Back Bay Exhaust Cleaning

Cleaning and Inspection of Commercial Hood and Ventilation System & Deficiency Report

R-001042

Harborside Noodle House
Attn: Sam Example
120 Hanover St, Boston, MA 02108

Riser, no access panel

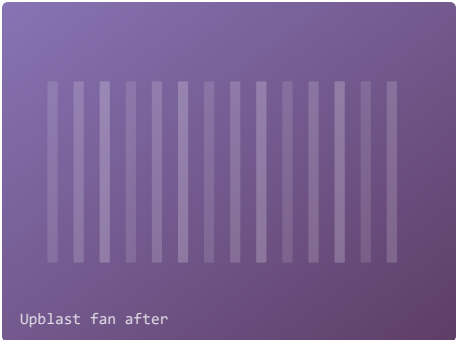
SECTION	ITEM #	DESCRIPTION OF DEFICIENCY
A	17	No access panel on the vertical riser between the 3rd and 5th floors.
A	16 / 19	Vertical duct above the 3rd floor could not be reached or cleaned.

Vertical riser above the 3rd floor: no access panel.

Owner advised to have an access panel installed on the riser before the next cleaning.
